Addendum No.: 2

Date Of Addendum: 09/26/18

CT DAS | Construction Services | Office of Legal Affairs, Policy, and Procurement

Master Plan Phase III Renovations and Additions
Norwalk Community College
188 Richards Ave.
Norwalk, CT
BI – CTC – 467

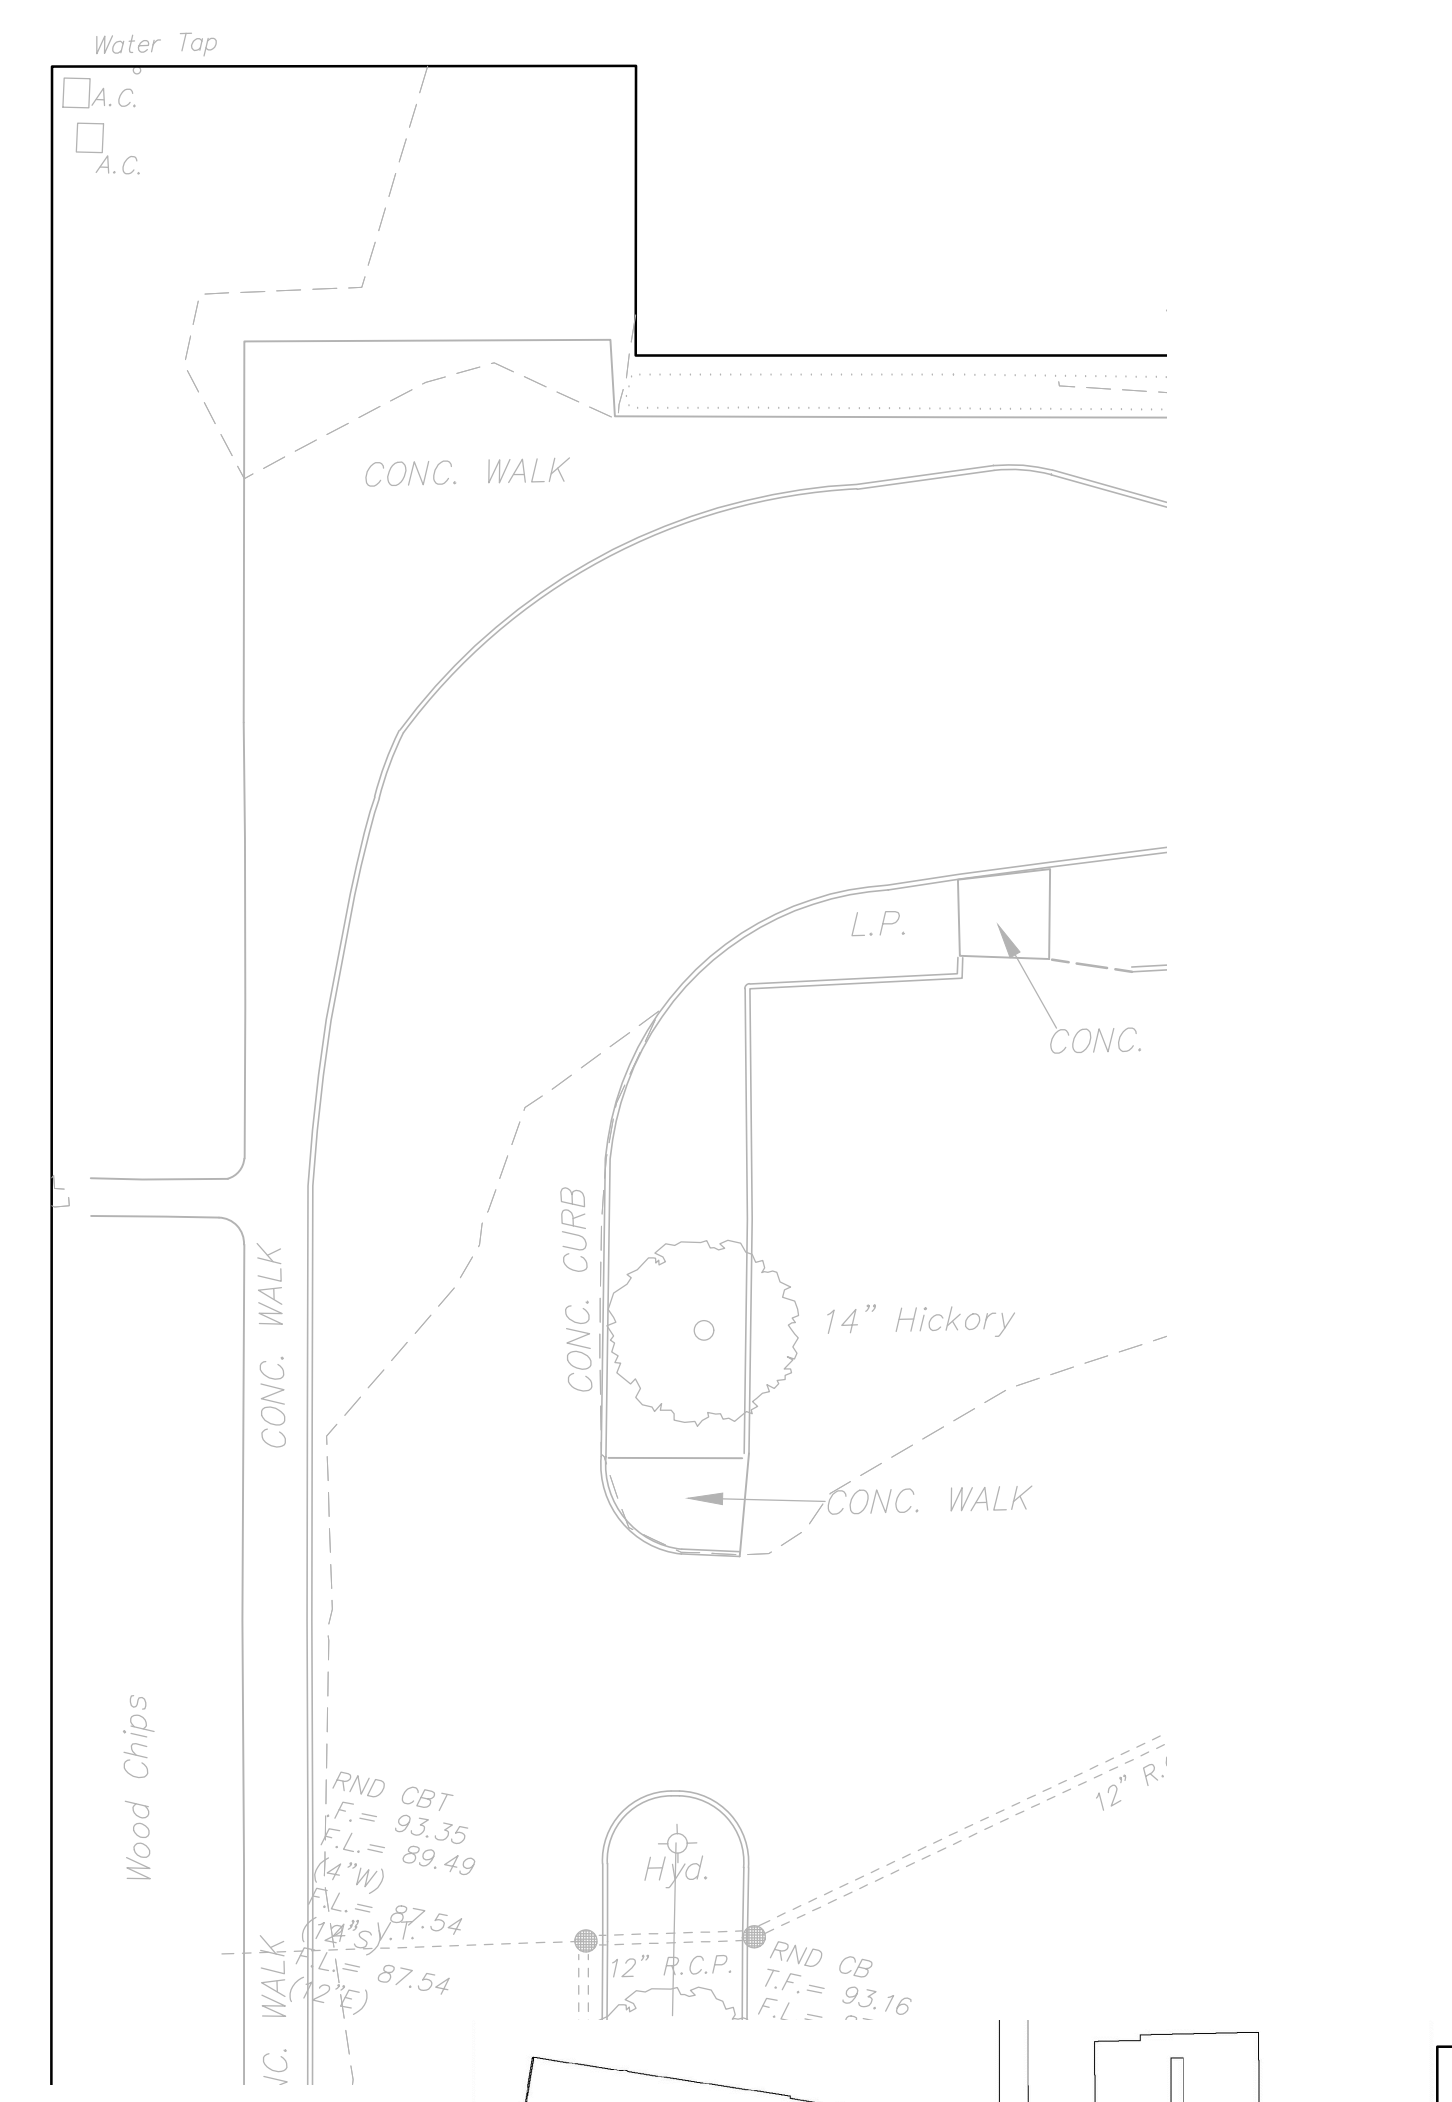
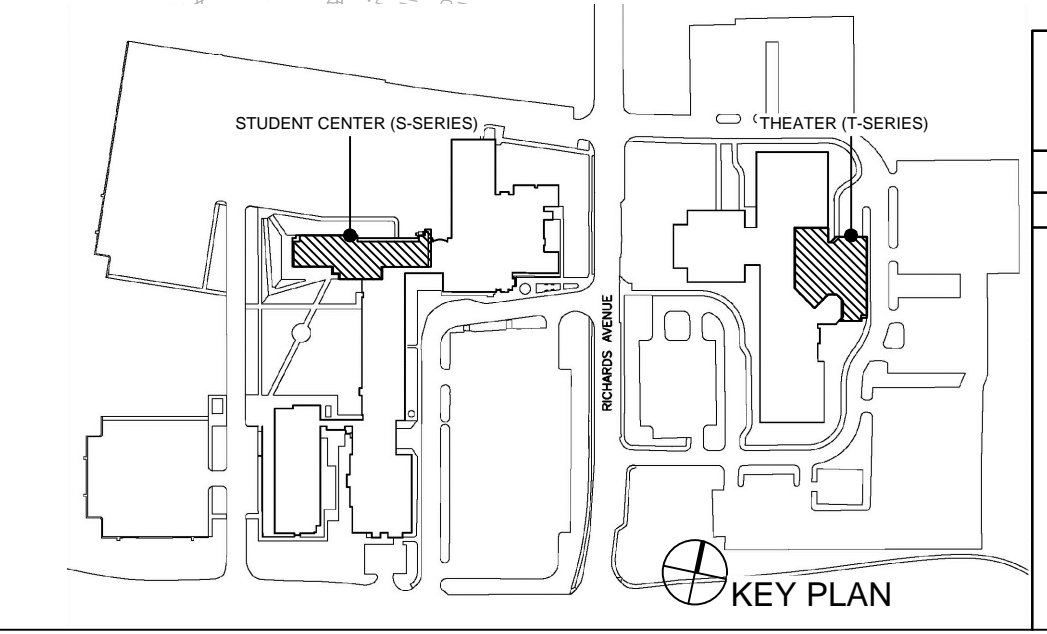
Question: C101A Student Center Demo Plan shows bituminous apron or walk at the area of the existing building where the proposed addition is to be installed yet on the demo plan this work is not addressed, please clarify.

C101A – revised, Addendum No. 2, 09/21/18: To reflect the removal of existing apron/walk.

Response: C101A Student Center Demo Plan has been revised to reflect the removal of the existing bituminous apron/walk in the area of the proposed addition. The revision is reflected in the attached drawing set.
